Final Drainage Report – Filing No. 1

Waterview East Commercial El Paso County, Colorado

Kimley-Horn and Associates, Inc.

Prepared: July 16, 2026

DETENTION BASIN OUTLET STRUCTURE DESIGN

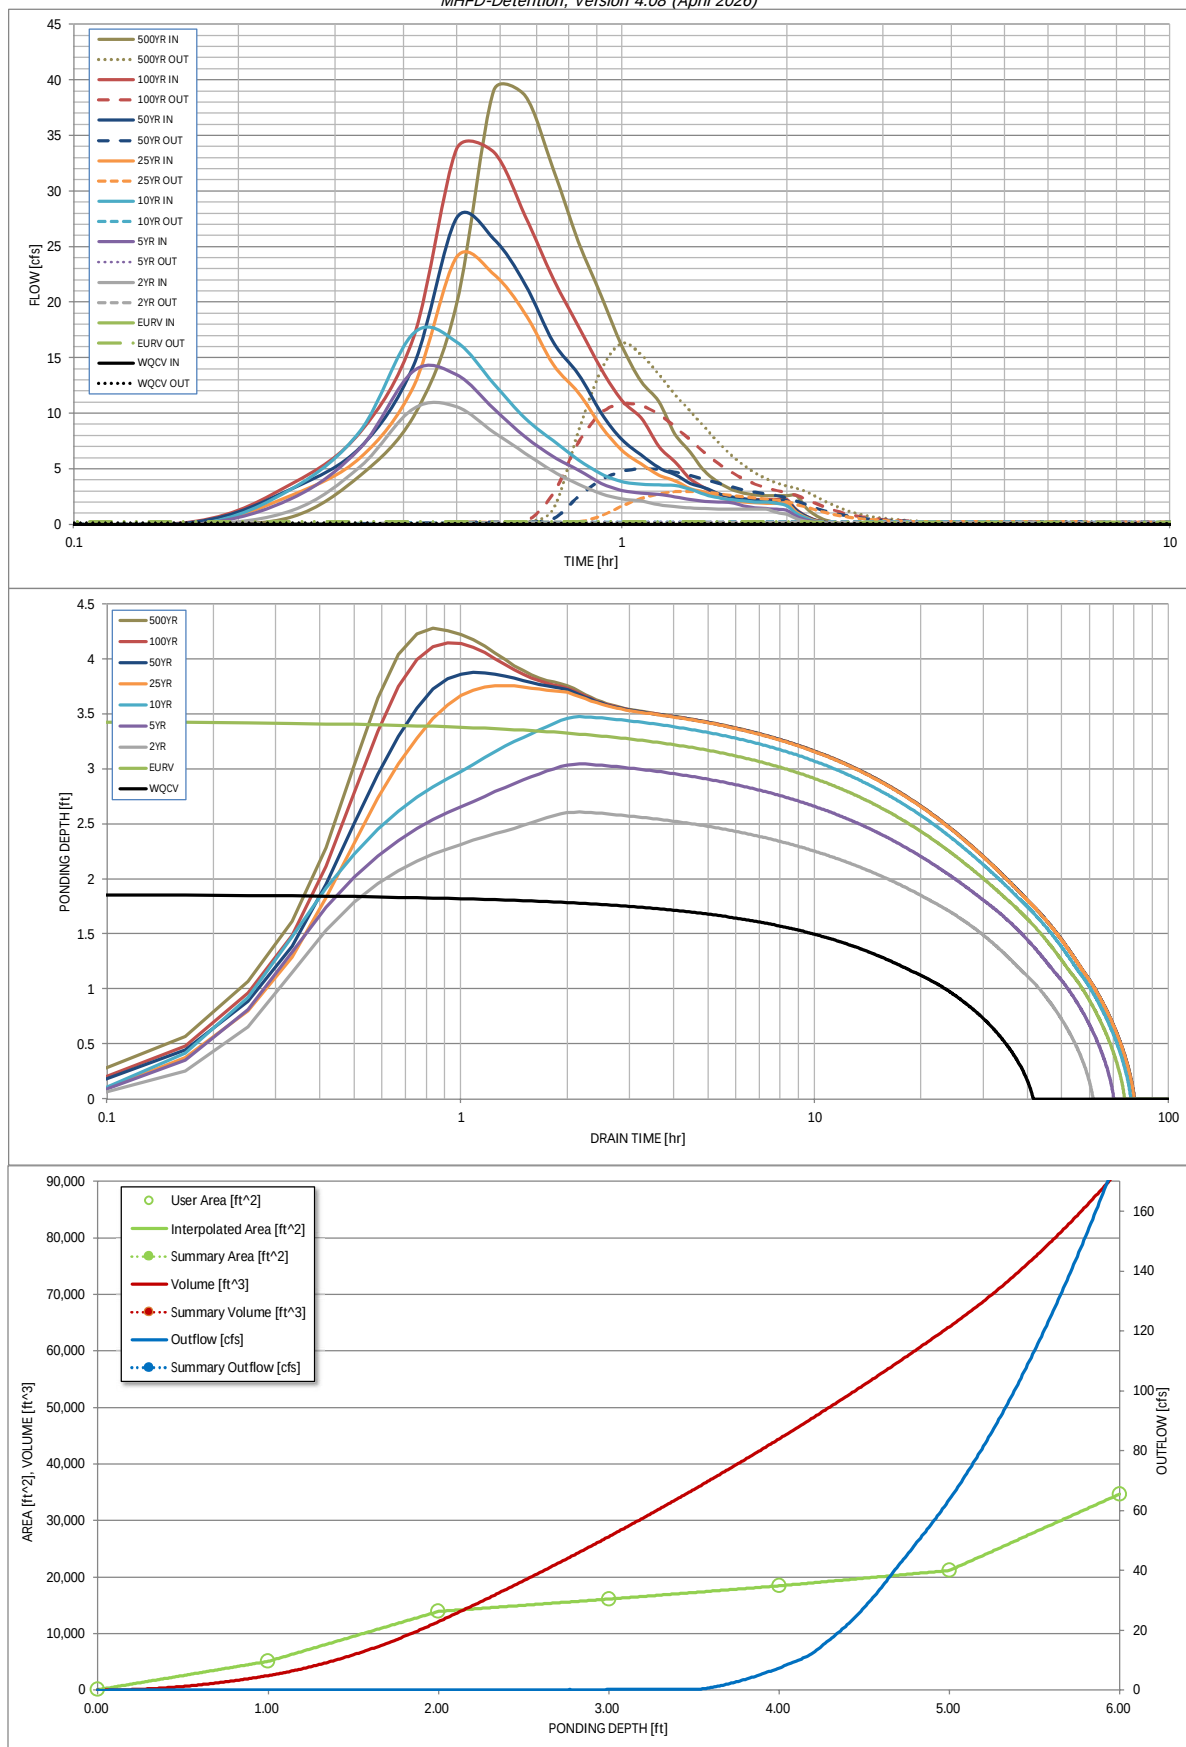
where did you get this value from? I see 3ft on the plans.

where did you get this value from? I see 4ft on the plans.

KH Response:
Dimensions in plan updated

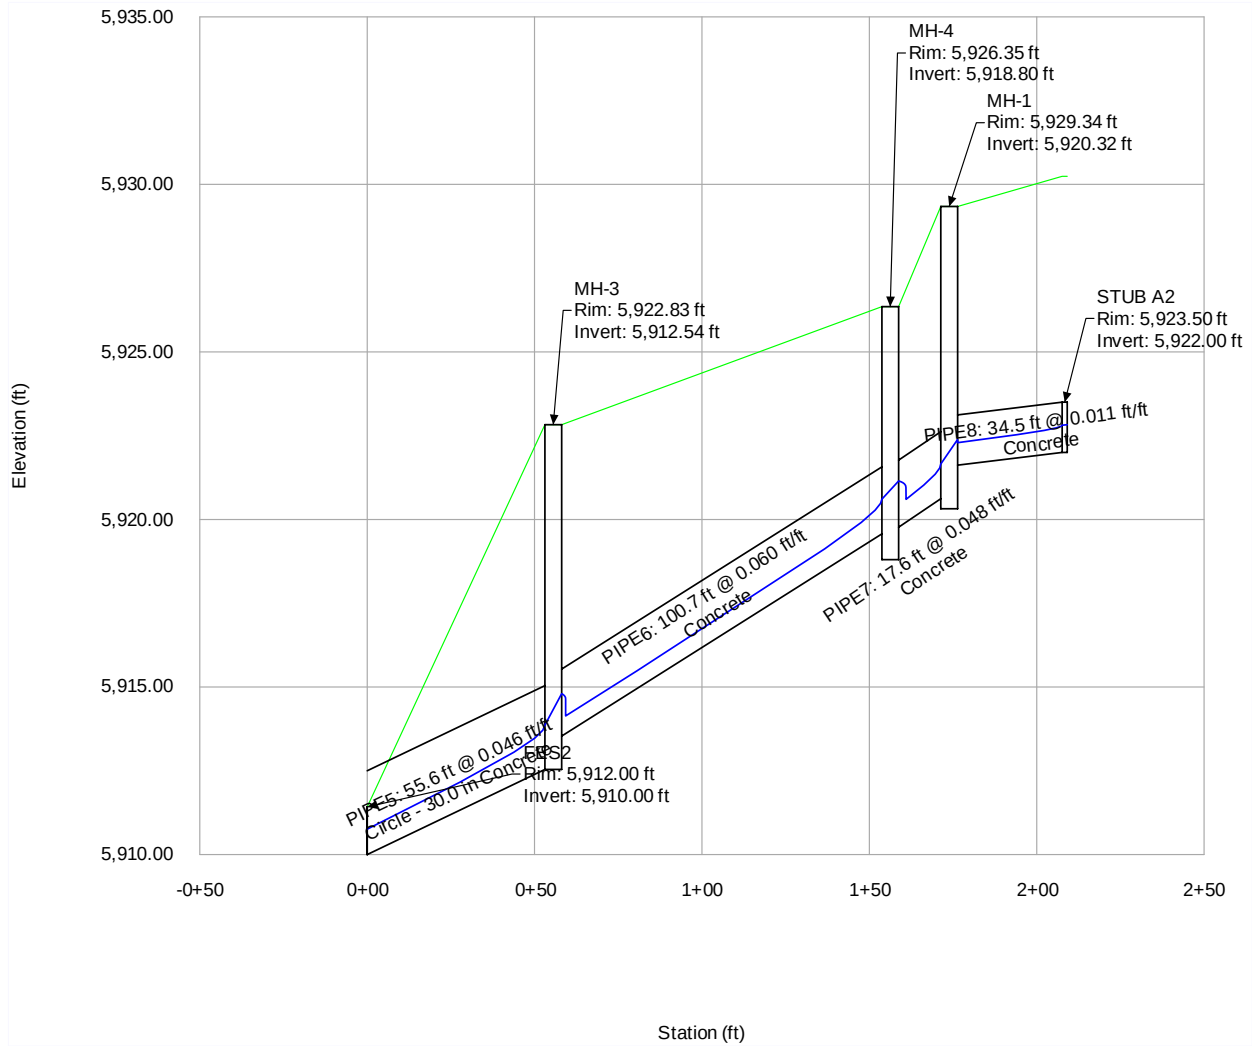
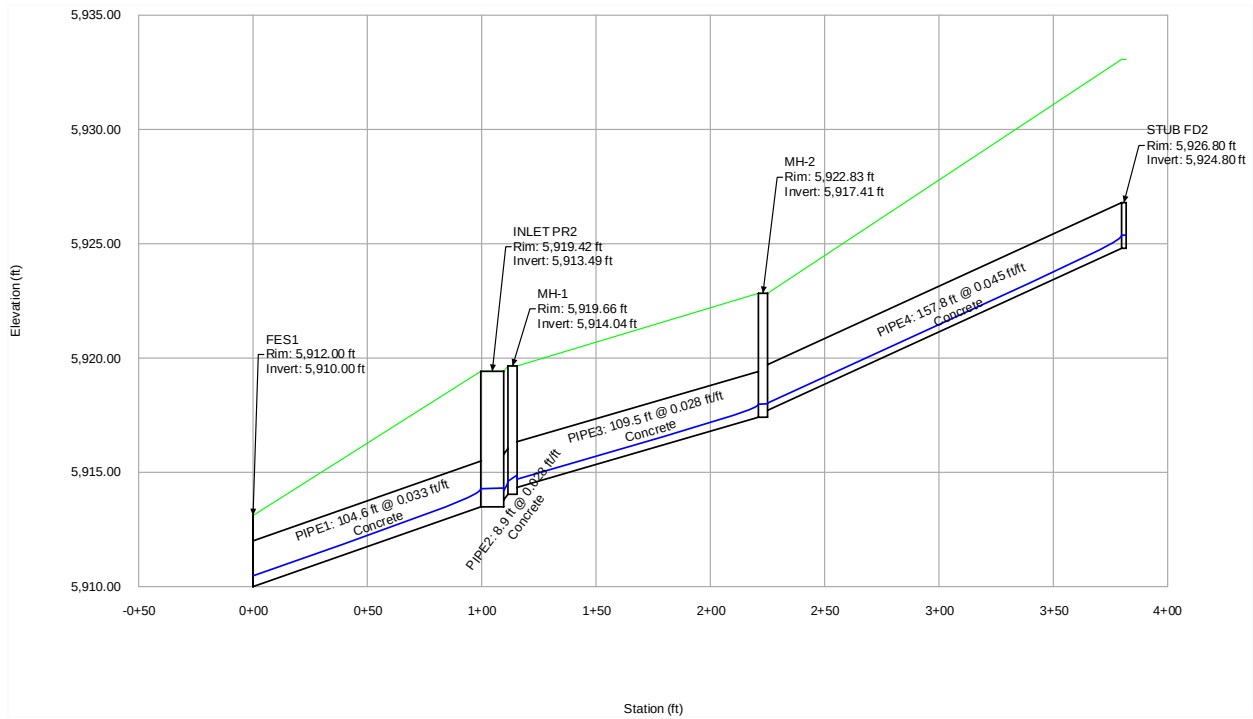
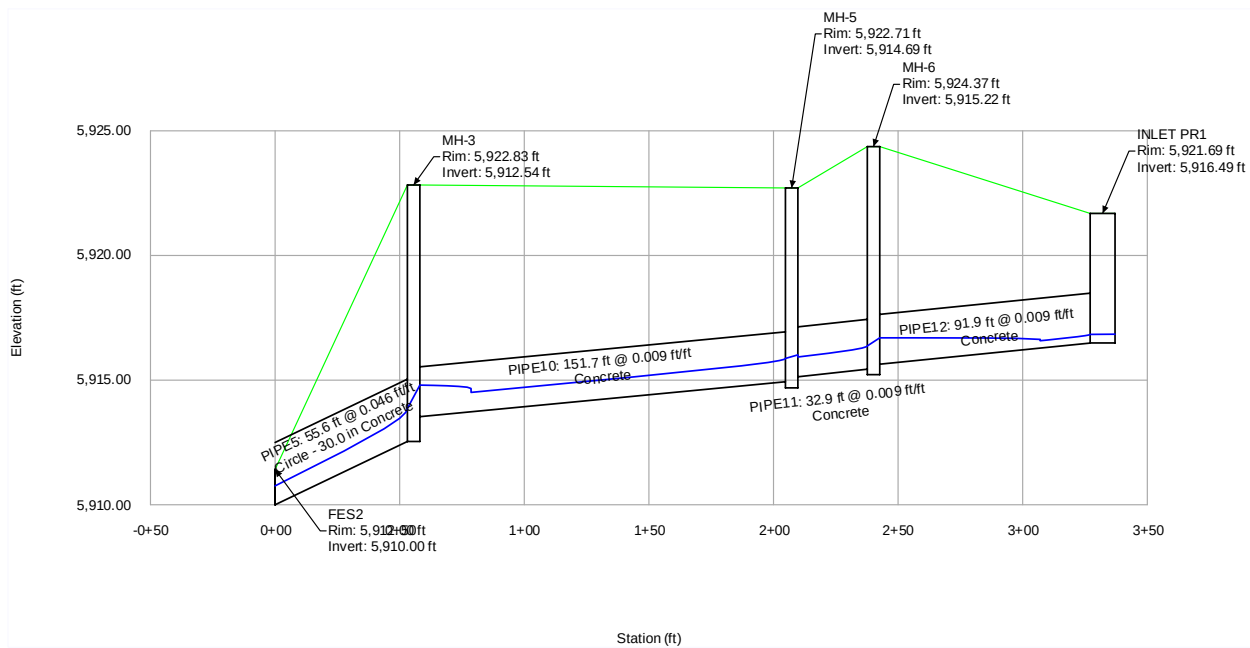
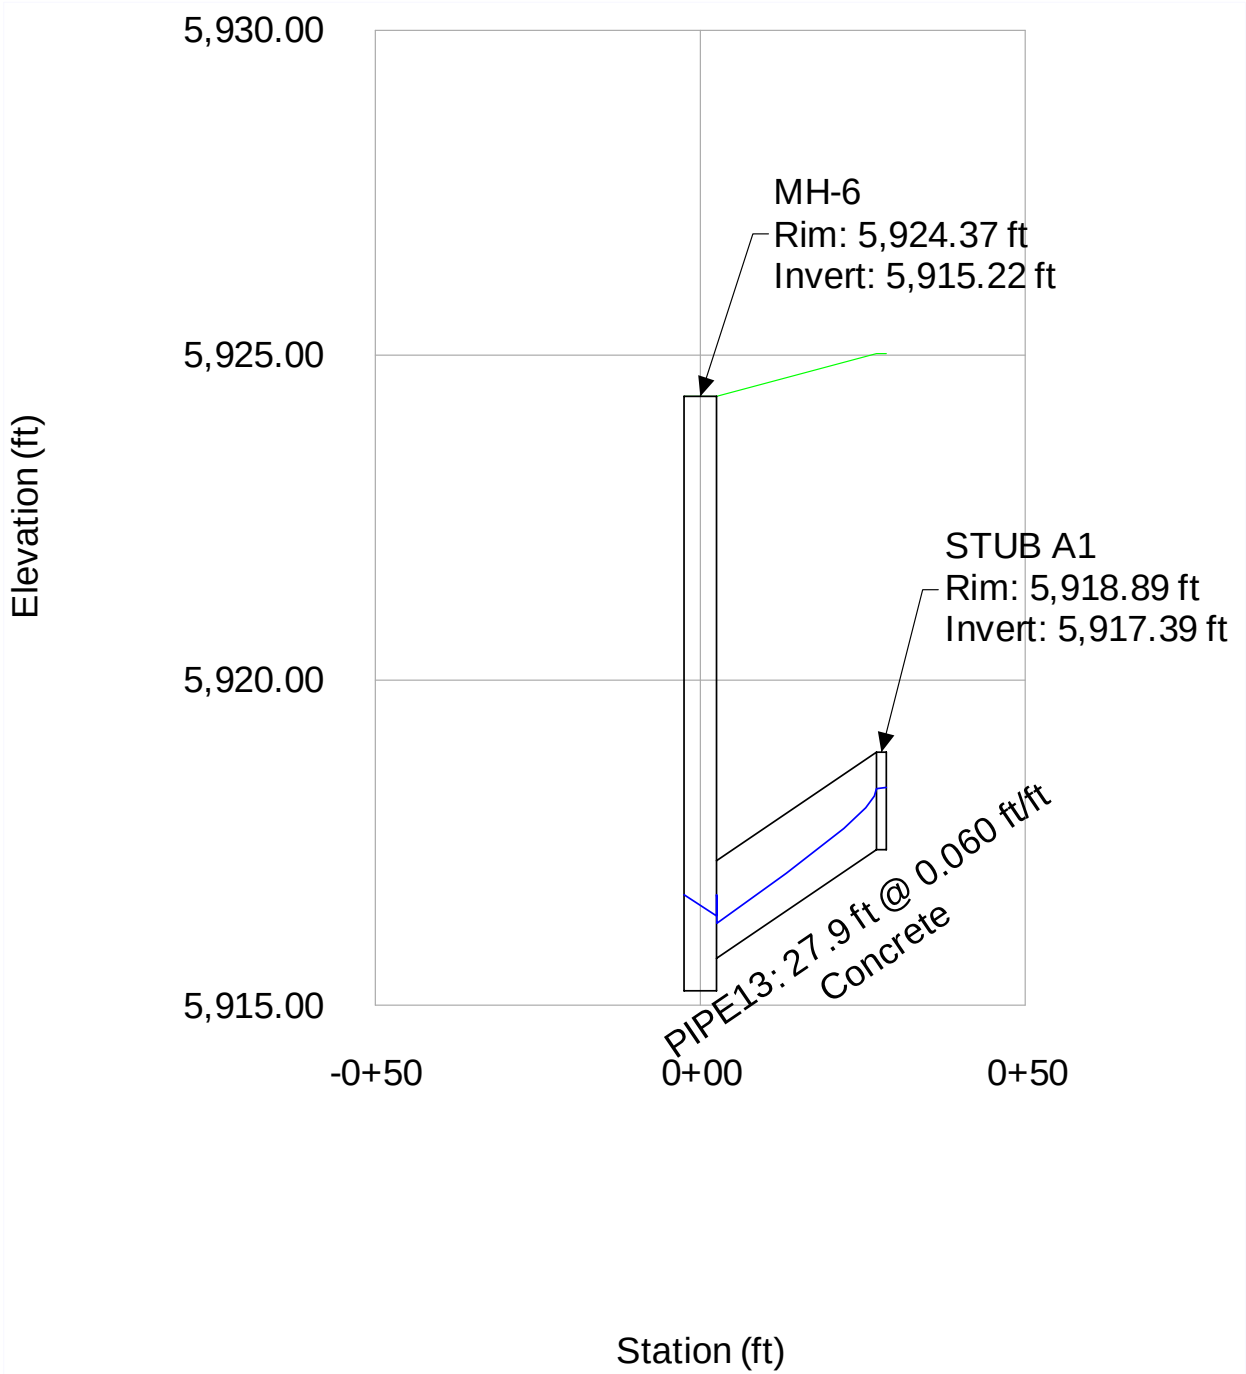
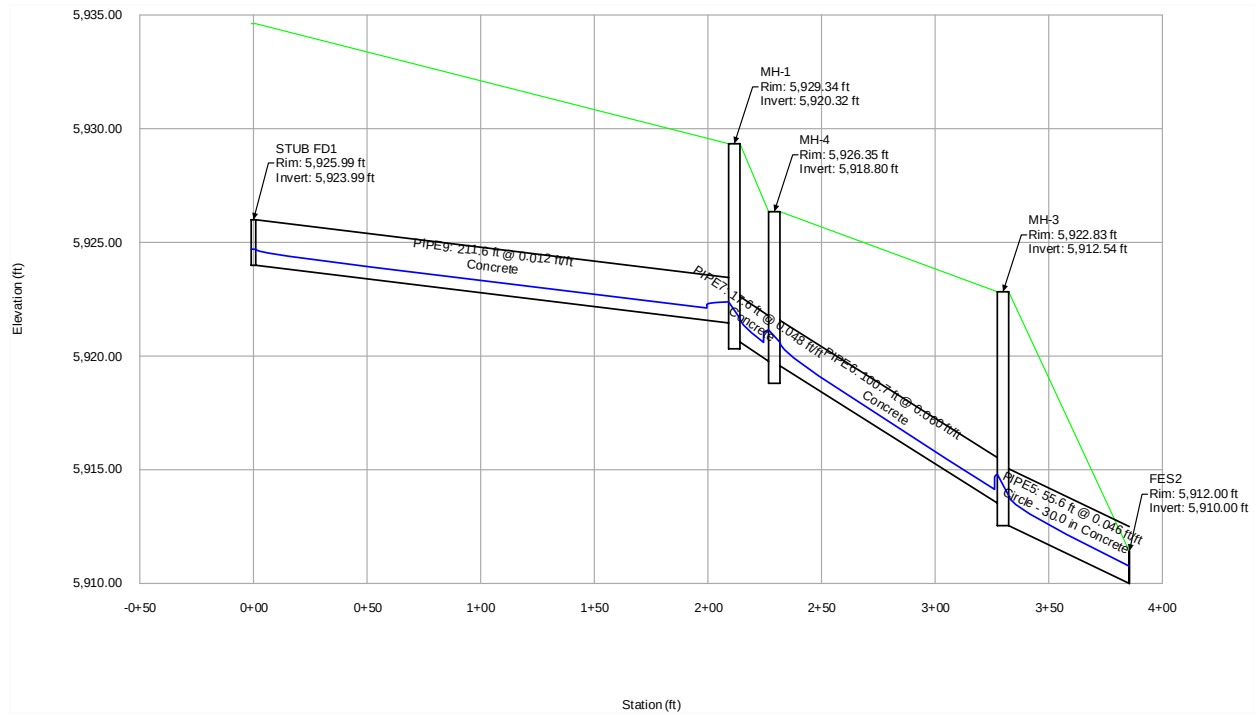
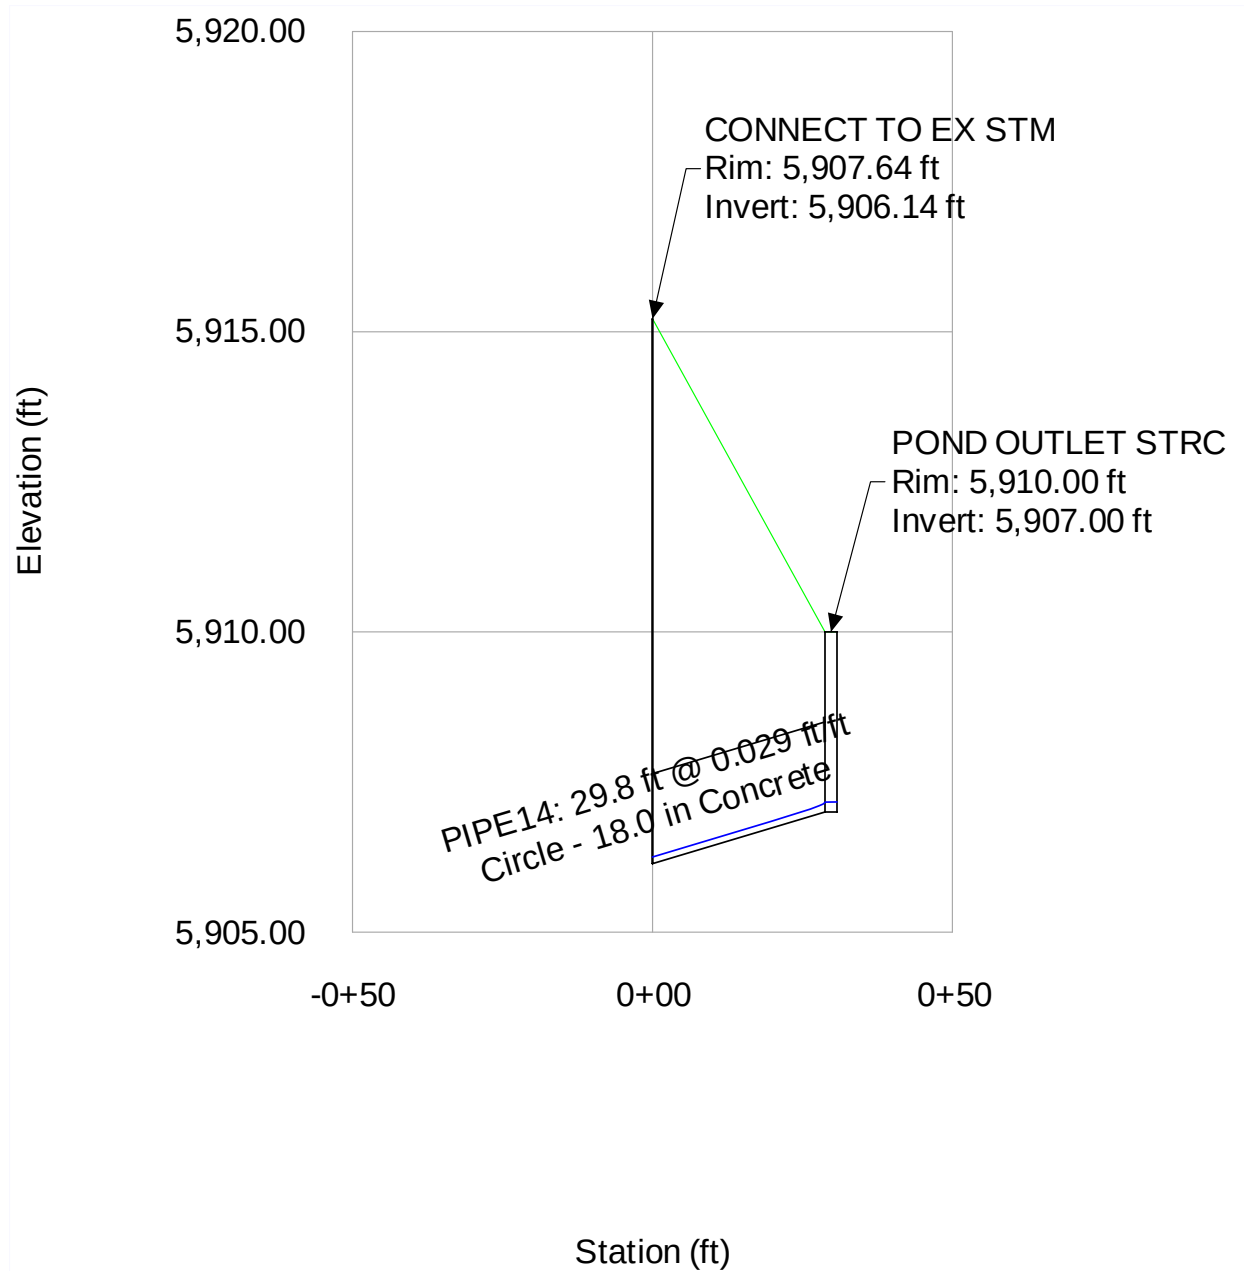
Highlighted values do not match what is shown on the storm plan and profile sheets in the construction drawing plan set (Sheets C4.11-C4.14). Please review and revise.

Highlighted values do not match what is shown on the storm plan and profile sheets in the construction drawing plan set (Sheets C4.11-C4.14). Please review and revise.

KH Response:
Values updated to match what is shown in plans

KH Response:
Values updated to match what is shown in plans
